**SERVICE BULLETIN**

**APPLICABILITY:** 2017-20MY Impreza  
 2018-20MY Crosstrek  
 2019-20MY Forester  
 2015-20MY WRX  
 2019-20MY Ascent

**NUMBER:** 12-306-20R

**SUBJECT:** Front Seat Squeaking Sound

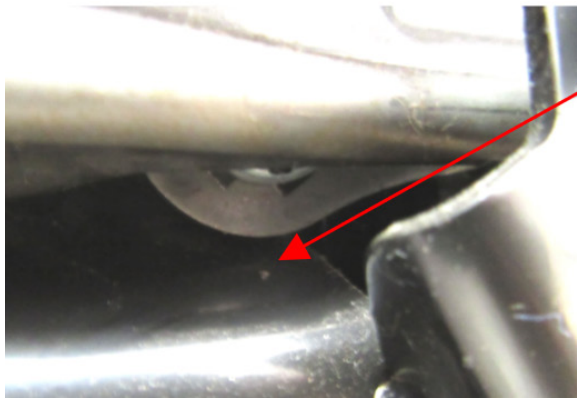
**When the Lifter is at the top position, there is space between the Lifter and the Bracket.**

**When the Lifter is at the bottom (lowest) position, there is only a very small gap between the Lifter and the Bracket. In some cases, there may be a small “witness mark” created by the contact usable as a guide for where grease must be applied.**

- 6) Apply Conoco-Phillips Red Grease #2 (or a suitable **Silicone-Free** equivalent) to the area shown below on both the outer AND inner contact points.
